# DEVELOPMENT REVIEW BOARD REPORT

CASE NUMBER/ PROJECT NAME	<b>Lot 22 @ Perimeter Center - DHL Campus 68-DR-2000#4</b>		
LOCATION	8660 E. Hartford Drive		
REQUEST	Request approval of a site plan and elevations for a new office building and raised parking deck.		
OWNER	Desert Troon Limited LLC 480-955-3900	ENGINEER	WRG Design 602-998-8900
ARCHITECT/ DESIGNER	Butler Design Group Clay Chiappini 602-957-1800	APPLICANT/ COORDINATOR	Tom Rief Land Development Services LLC 480-946-5020

**Stipulations for Case:  
Lot 22 @ Perimeter Center – DHL Campus  
Case 68-DR-2000#4**

# DEAD-END PARKING AISLE DETAIL

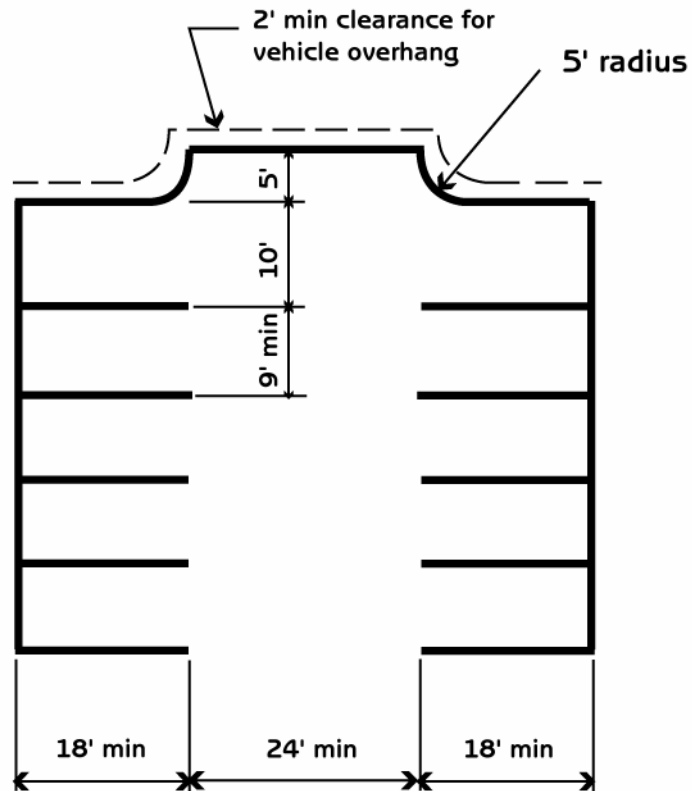
38. The developer shall design the dead-end parking aisle in general conformance with the included detail.

## NOTES:

1. Maximum dead-end parking aisle length is 150 feet.
2. If the length exceeds 150 feet, a turn-around shall be provided for emergency vehicles.
3. No refuse enclosures are permitted on a dead-end aisle.
